UNITED STATES
NUCLEAR REGULATORY COMMISSION

SUBJECT: REVISION TO POSSESSION LIMITS AND RADIATION PROTECTION PROGRAM
(TAC NO. L30696)

SUBJECT: SAFETY EVALUATION REPORT: APPLICATION DATED AUGUST 3, 1994,
REVISION TO POSSESSION LIMITS AND TO RADIATION PROTECTION
PROGRAM

Figure 1 Facility Layout Map

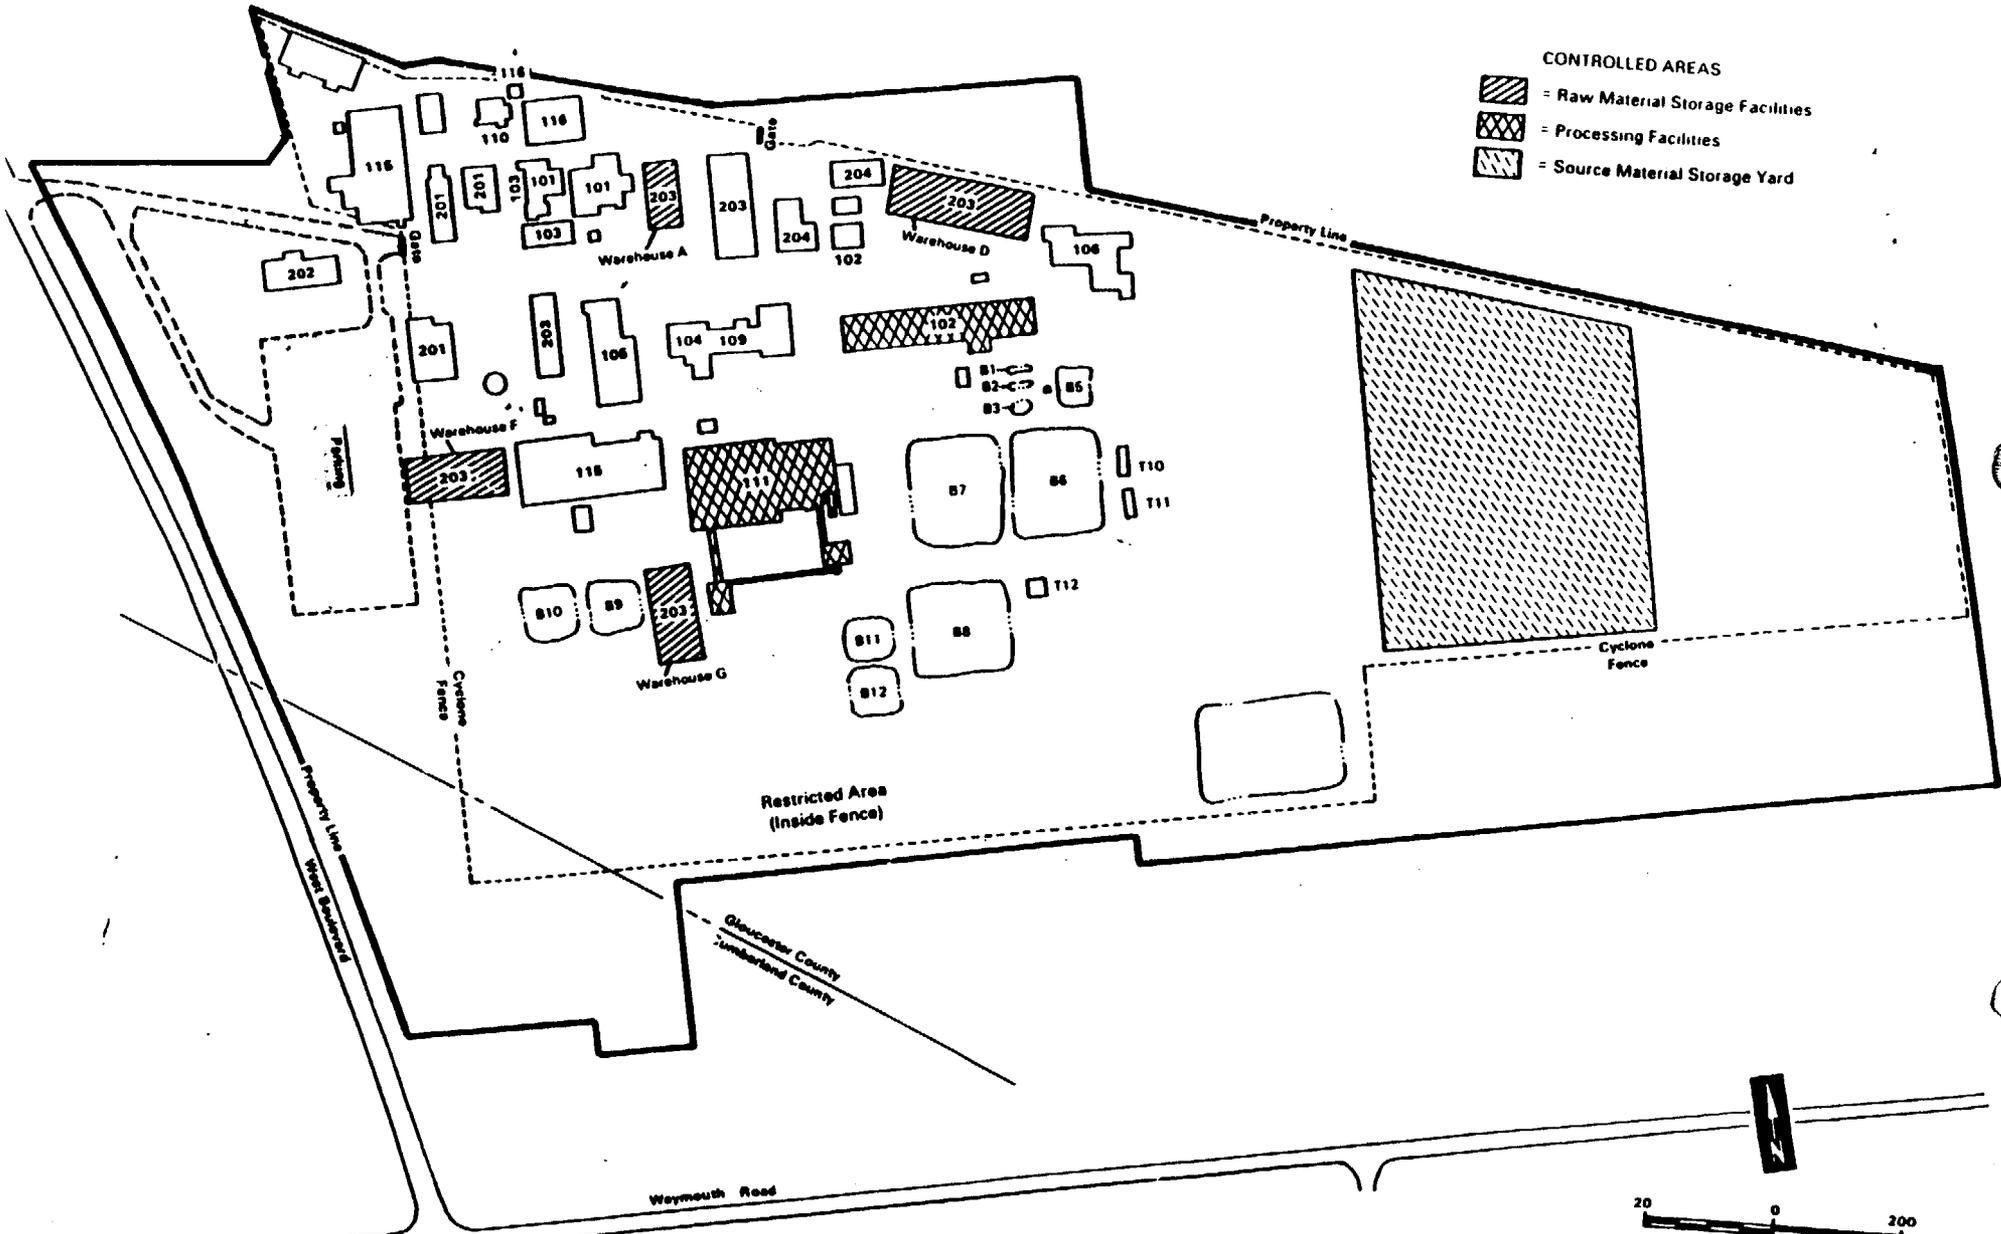
The direct gamma dose to workers from the piles in the Source Material Storage Yard (SMSY), where slag and baghouse dust is stored (see Figure 1), is not expected to vary significantly by addition of the licensed material, since its concentration of source material will only be minimally increased and the piles are thick enough (greater than 1 meter) to be considered as infinitely thick sources. Similarly, the dose from inhalation of resuspended dust is expected to be unaltered because the surface area of the lime dust pile will not substantially increase.
